February 11, 2010

REFERENCE: Docket 50-407
The University of Utah – TRIGA Research Reactor (UUTR)
License No. R-126

SUBJECT 1): **Copy of the markedup current TS: only the Chapter 6.0 titled ADMINISTRATIVE CONTROLS (the rest of the TS document was not changed and is the same as the one submitted as part of the SAR documentation dated Jun 2009)**

**TECHNICAL SPECIFICATIONS AND BASES FOR THE UNIVERSITY OF UTAH
TRIGA NUCLEAR REACTOR**

Figure 6.1

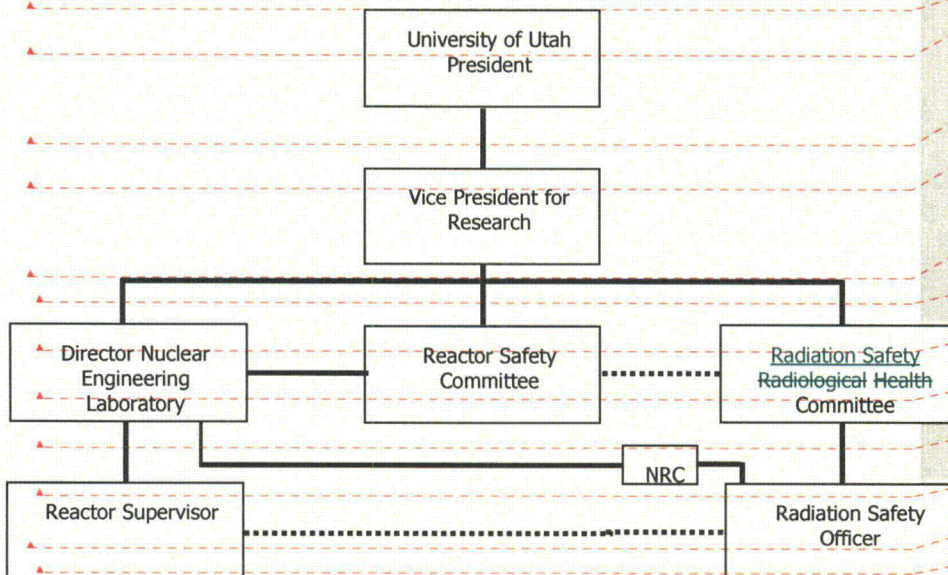
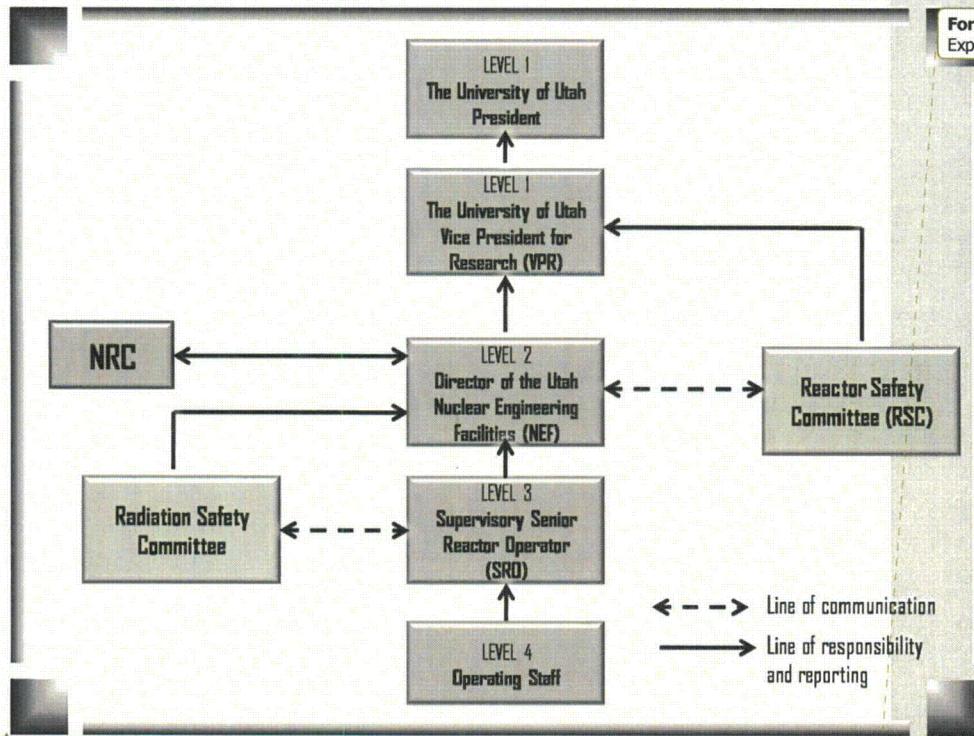
The University of Utah TRIGA research reactor (UUTR) is submitting the clarification in administrative controls, especially clarifying the organizational chart shown as Figure 6.1, Pg. 26 in the current TS Chapter 14, Chapter 6.0. The organizational chart is redrawn to more clearly show the organization and management, lines of communication and lines of responsibilities and reporting. This is designed to be in full compliance with the ANSI/ANS 15.1-2007, ANSI/ANS 15.4-2007 and NUREG 1537 Part 1 & 2. The wording of the textual part of the Chapter 6.0 was revised as markedup, and in compliance with the ANSI/ANS 15.1-2007, ANSI/ANS 15.4-2007. According to our line of communication and reporting, the Chair of the Reactor Safety Committee and the Associate VP for Research, have approved the clarifications provided in the markedup document.

Comment [tj11]: This figure is replaced with the new one that clarifies lines of responsibility and lines of communication

Comment [tj12]: Clarified Organizational Chart

- 2) **As indicated in Fig. 6.1, the Reactor Safety Committee shall report to Level 1. Radiation safety personnel shall report to Level 2. Additional description of levels follows:**

- a. **Level 1: Individual responsible for the reactor facility's licenses, i.e., the Associate Vice President for Research in the Office of Vice President for Research; The Vice President for Research will assign which of the Associate Vice Presidents for Research will be the responsible Level 1 individual.**

- b. **Level 2: Individual responsible for reactor facility operation, i.e., the facility director shall be the Director of the Utah Nuclear Engineering Program, who shall also be the Director of the Nuclear Engineering Facilities (NEF) of the University of Utah.**

- c. **Level 3: Individual responsible for day-to-day operation or shift shall be the reactor supervisor (RS). This person shall be a senior reactor operator (SRO).**

Figure 6.1
University of Utah Administrative Organization for Nuclear Reactor Operations [Clarified - December 2009; in compliance with ANSI/ANS 15.1-2007]
